# LANCER.

# **Technical Bulletin**

Volume 21, Issue 10, December, 2014

# **Possible Electrical Transformer Defect**

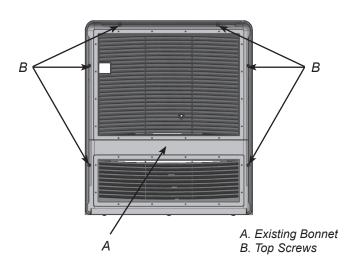
Lancer is proud to introduce an aesthetic enhancement for the Delta III Pro unit bonnet. This structural improvement was made with our efforts to continually provide added value such as overall unit strength and stability based on customer feedback from some of our fastest growing markets.

1. Remove existing bonnet by first removing the three (3) front panel support screws.

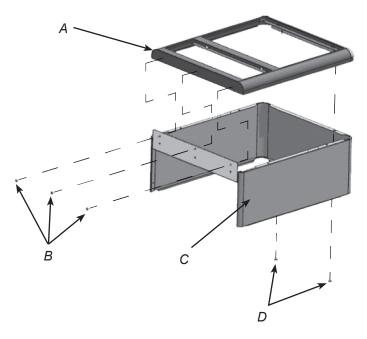
2. Remove the six (6) top screws then remove existing bonnet.

3. Install new metal bonnet to existing frame using the existing three (3) front panel support screws and the two (2) top hex nuts supplied.
